Subject: AP1000 Response to Request for Additional Information (SRP6.2.2)

Response to Request for Additional Information on SRP Section 6.2.2

RAI Response Number: RAI-SRP6.2.2-CIB1-31
Revision: 1

RAI Response Number: RAI-SRP 6.2.2-SPCV-25
Revision: 2

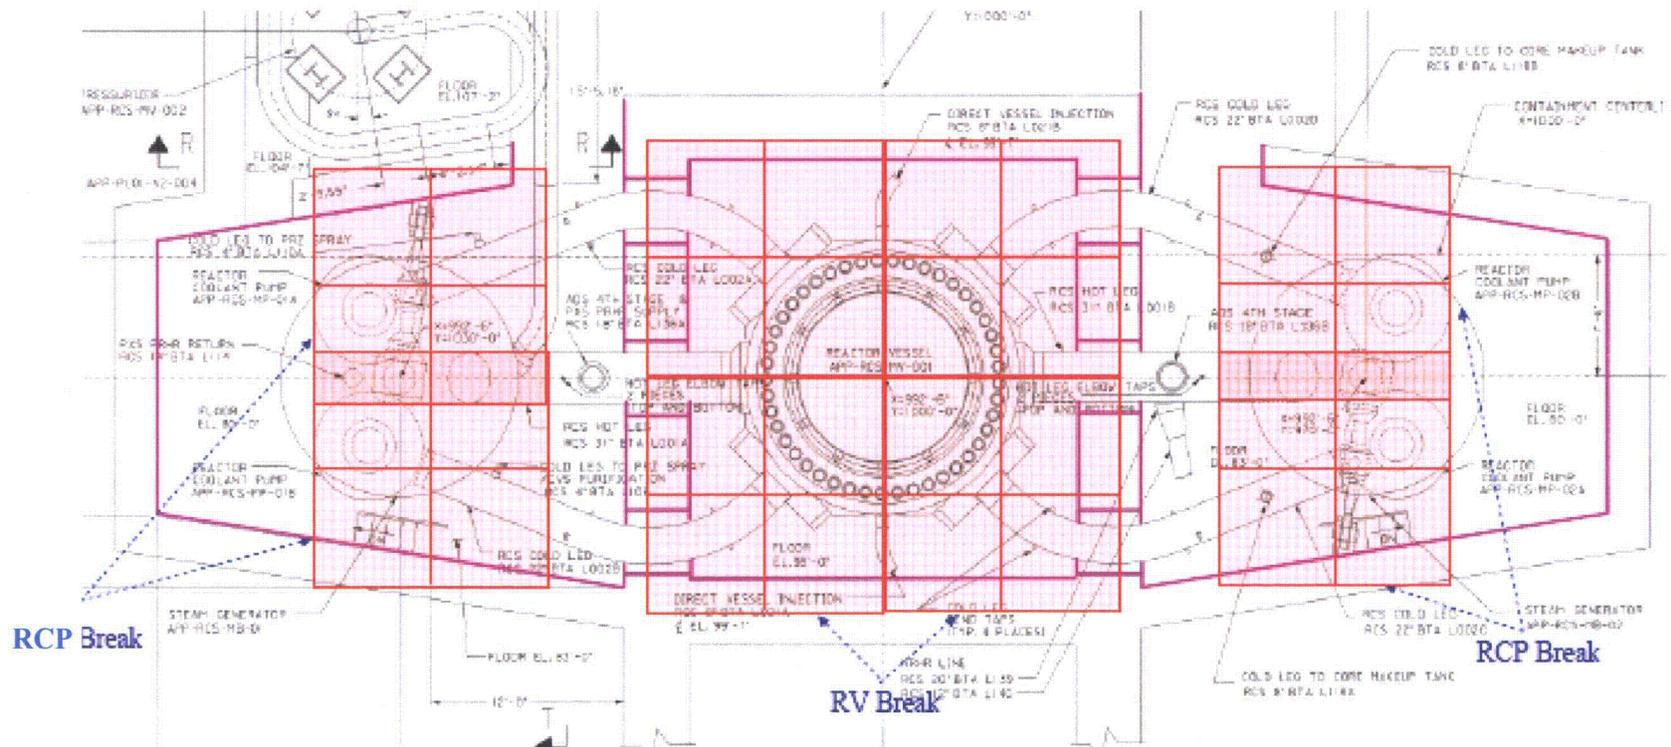
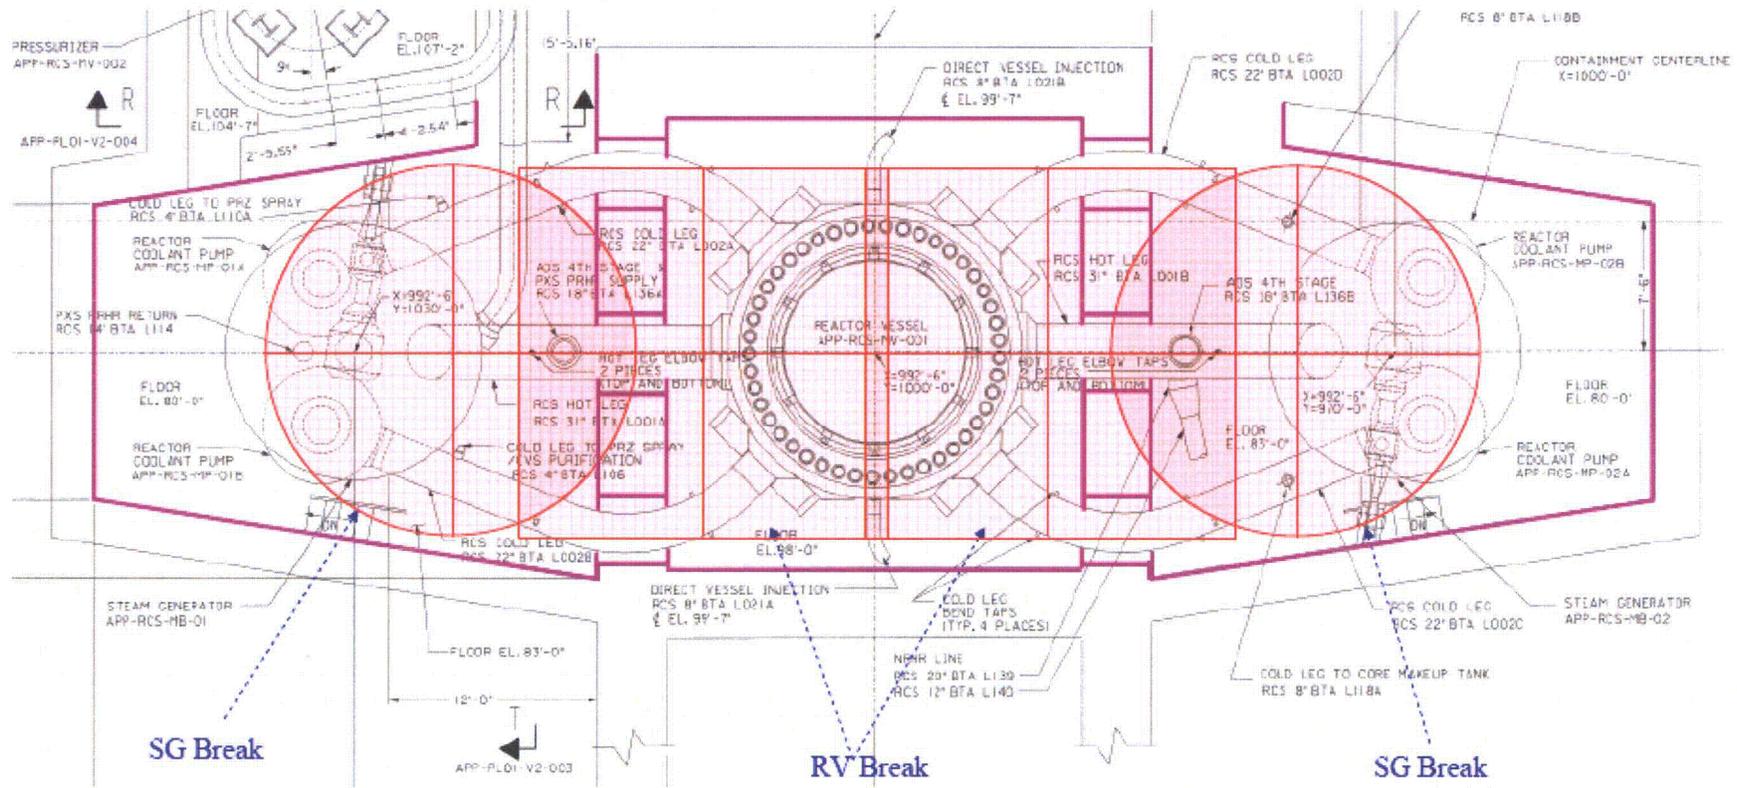
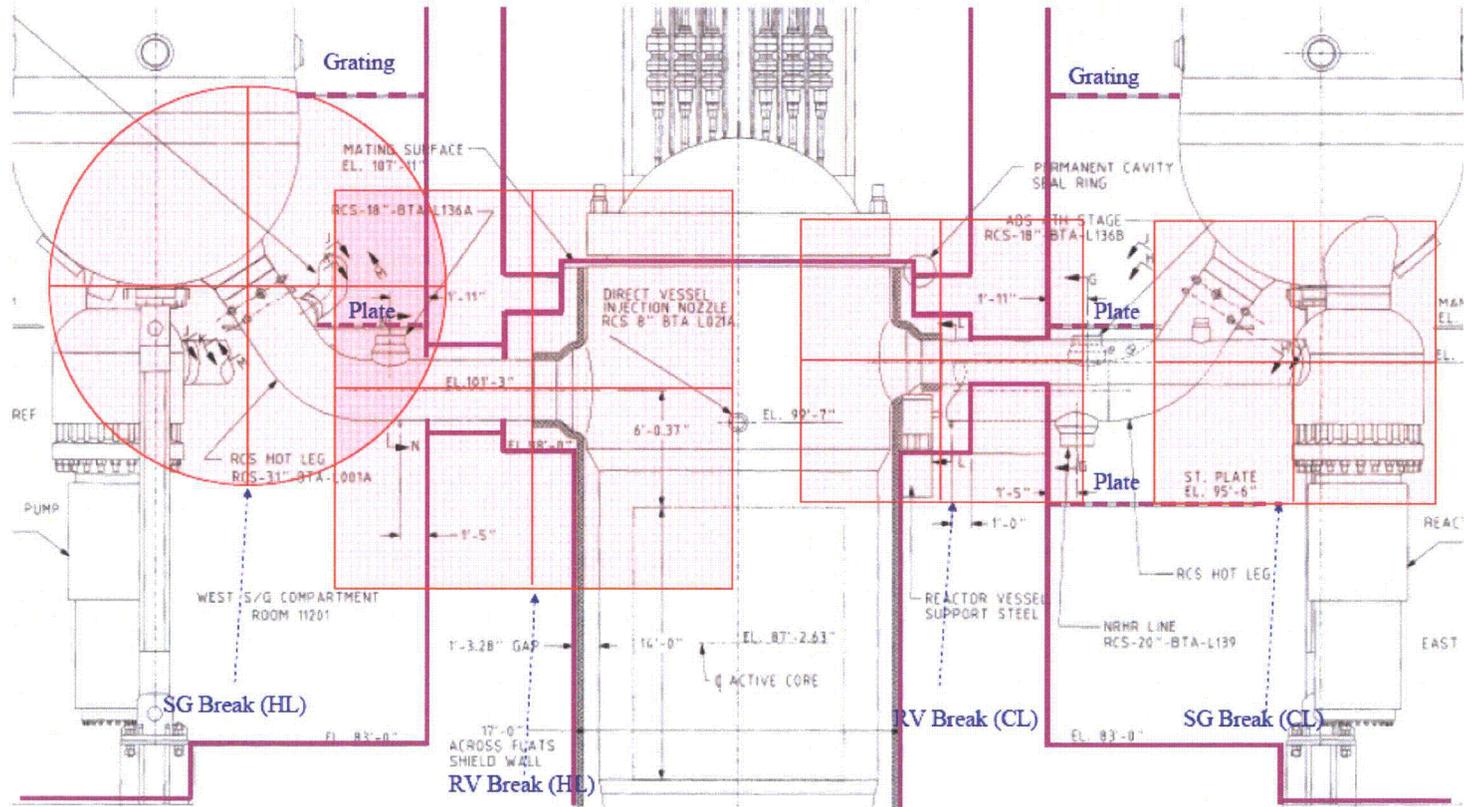
- a) The Revision 1 response to RAI-SRP 6.2.2-SPCV-25 described the evaluation of breaks at the terminal ends of the hot leg and cold leg lines. Per the SE on NEI 04-07, additional break locations can either be evaluated at 5 ft intervals or driven by the comparison of debris source term and transport potential. In the RAI response, the terminal end that produced the largest amount of coating debris was identified as the limiting break for that line and it was stated that additional break locations were not quantified because they were within the loop compartment and by inspection have similar characteristics, inventories and transport paths. The staff was unable to conclude from this statement, or from the supporting calc-notes, that the selected terminal end break location is limiting. Please provide justification as to why the amount of coatings on beams, pipes and surfaces in a ZOI centered at the cold leg/reactor coolant pump or hot leg/CL /steam generator bound all potential cold leg and hot leg breaks in the loop compartments.

The specific break locations quantified for the CLs and HLs were at the terminal ends. Figures 1, 2, and 3 show these break locations and the associated 4 D ZOIs that are used to quantify the amount of epoxy coatings.

Figure 10.3.2-1 (Sheet 1 of 2)

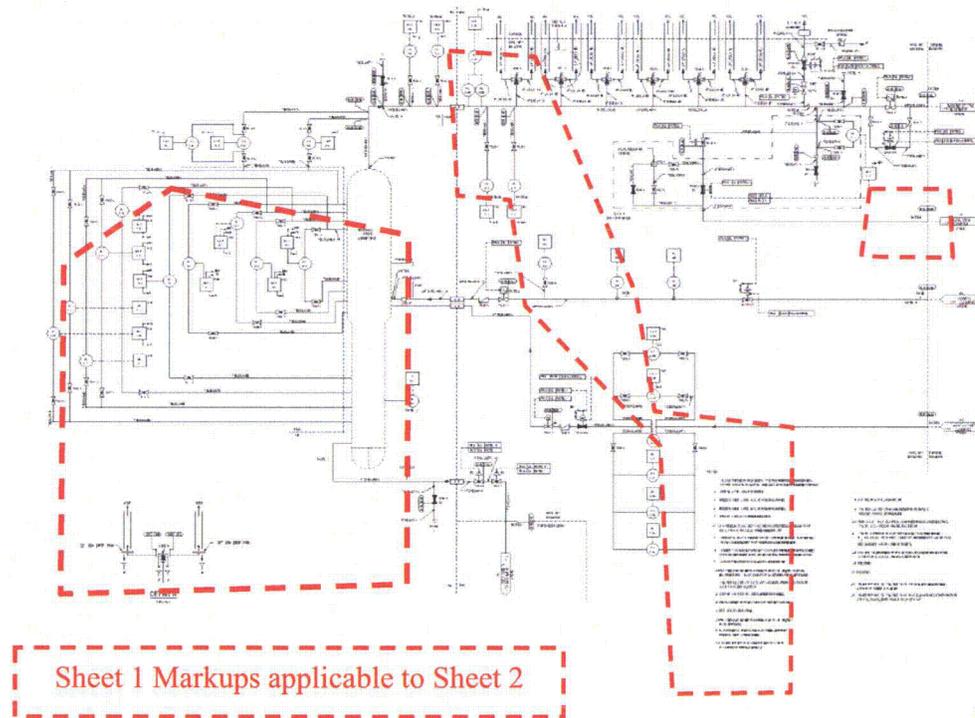
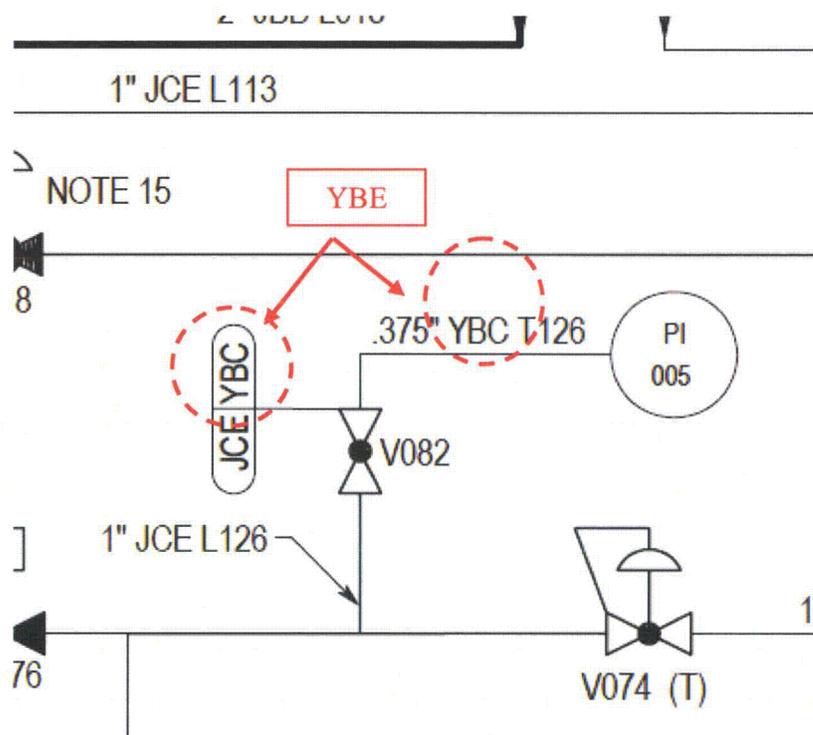
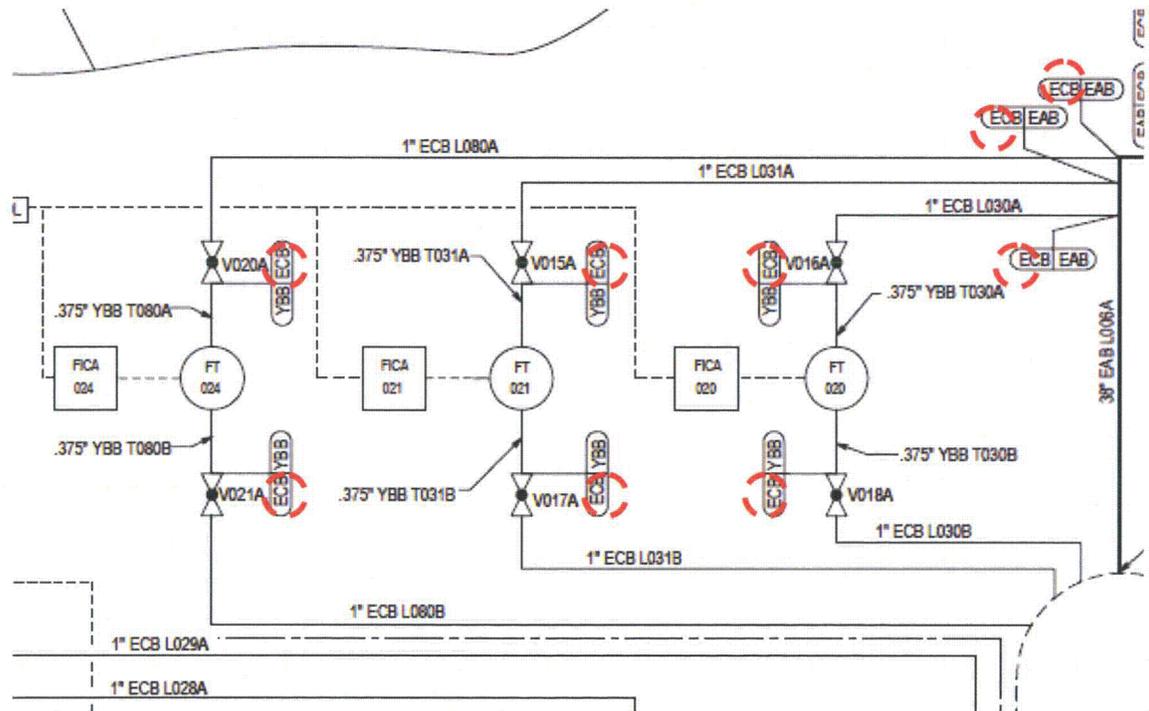
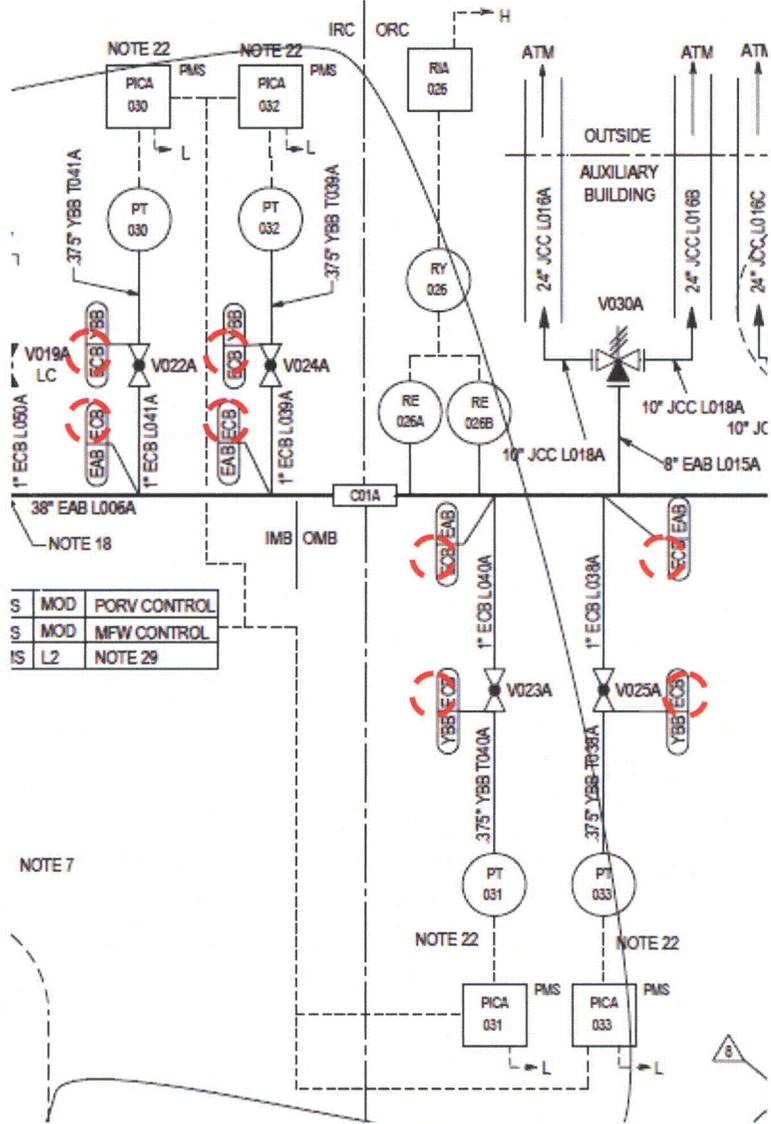
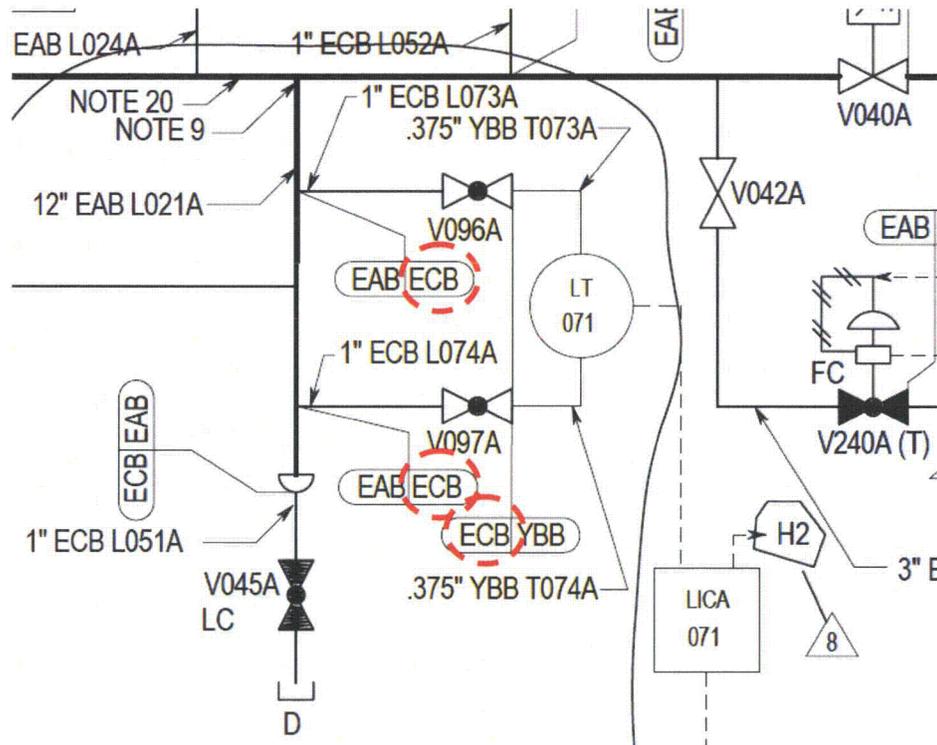
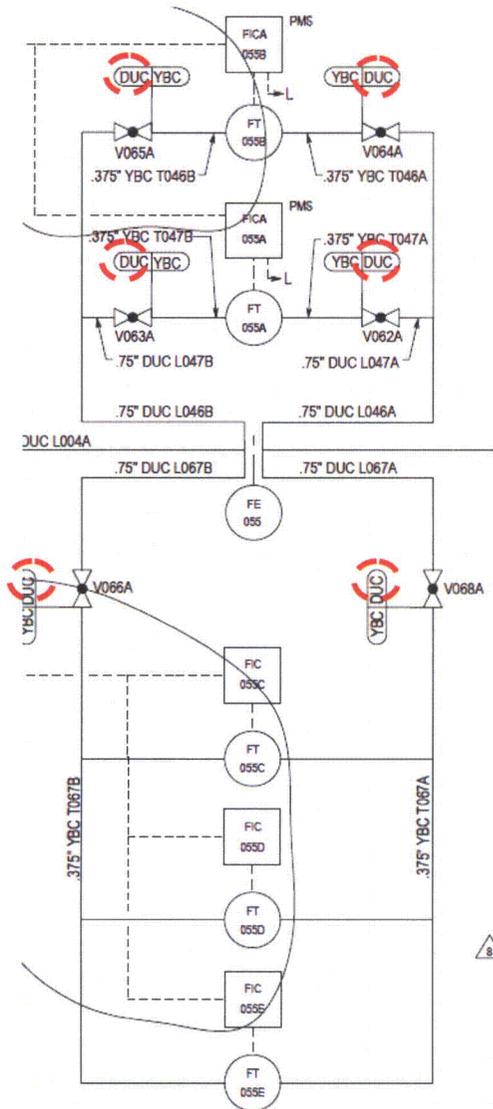
- d) In Section 5.2.2 of APP-PXS-M3C-013 R0, there is a statement that "only SGS piping will be effected and that DCP-1510 (Ref. 18) has changed the lines from carbon steel to stainless steel. Stainless steel will not be coated." The reference list does not provide a date for DCP-1510, which is also identified as APP-GW-GEE-1510. Please identify which lines were changed from carbon steel to stainless steel and when this change was made. Has this change been reviewed by the NRC? If not, discuss your plans to submit it for review, including related changes such as dissimilar metal welding.

- d) DCP-1510 (APP-GW-GEE-1510) was approved by the Westinghouse Change Control Board (CCB) on April 23rd, 2010. The DCP changed all Steam Generator System (SGS) ASME Section III instrument piping to stainless steel. The DCD changes resulting from DCP-1510 will be submitted to the NRC staff and included in the amendment request for the certified design (DCD Revision 18). The change to stainless steel instrument piping was made due to corrosion concerns. The welding of dissimilar metals in the SG is not different from what is already standard practice in the pressurizer where SS instrument pipes are welded to a CS pressure vessel. The DCD markups associated with DCP-1510 (APP-GW-

GEE-1510) are provided as Figure 13. APP-GW-GEE-1510 will be submitted to the NRC via DCP_NRC_002932.

Change:
All highlighted line classes to be changed to 'CBB'

Change:
All highlighted line classes to be changed to 'CBB'

Change:
All highlighted line classes to be changed to 'CBB'

All highlighted line classes to be changed to 'CBC'

In-addition to those proposed in RAI-SRP 6.2.2-SPCV-25, Rev 1, see changes to Figure 10.3.2-1.
